TIME

STACKED RIGHT?

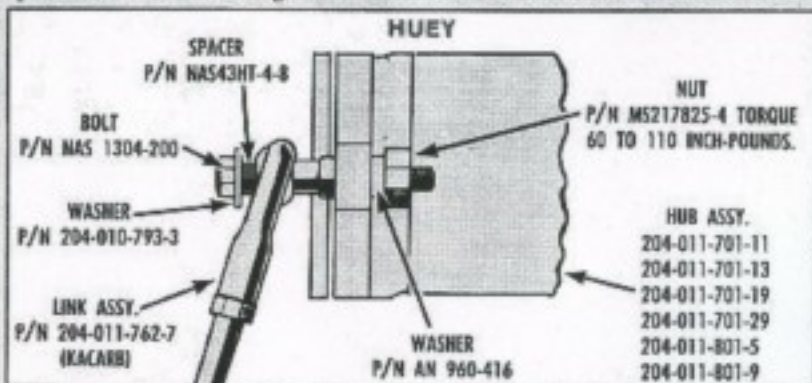
Take the tail rotor pitch change link stack-up with the new Kacarb bearing, for example.

With full right pedal and a partial flap of the tail rotor hub and blade, the inboard part of the bearing can contact the OD of the bolt washer—preventing the hub from hitting the static stop.

To prevent bearing damage, you can put spacer, P/N NAS43HT-4-8, between the bearing and the bolt washer on your Huey. Be sure you put the spacer side of the bearing inner race toward the threaded end of the bolt.

On the HueyCobra, make the spacer from washer, AN 960-C416, by opening up the ID to .013-.320 inch. Assembly is the same as for the Huey.
